Inland Transport Committee

Group of Experts on Improving Safety at Level Crossings

Proposed amendments to the 1968 Convention on Road Signs and Signals

Submitted by the Russian Federation, European Railway Agency (ERA) and Instytut Kolejnictwa (Poland)

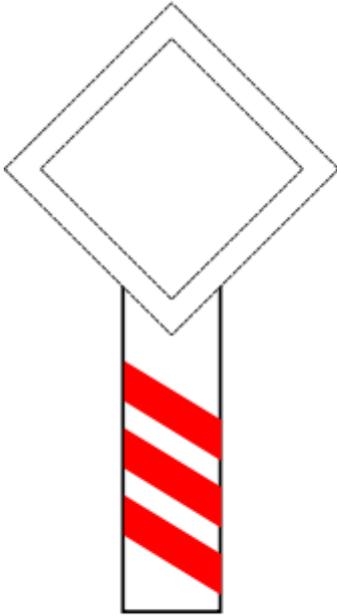
Drafting note: Group of experts to discuss the above proposed new sign.

A standard message for barrier arms at level crossings:

A green support with red wording “clear out by breaking the barriers”

Drafting note: The secretariat requests a visual image of the above proposed sign from the subgroup/Group of Experts.
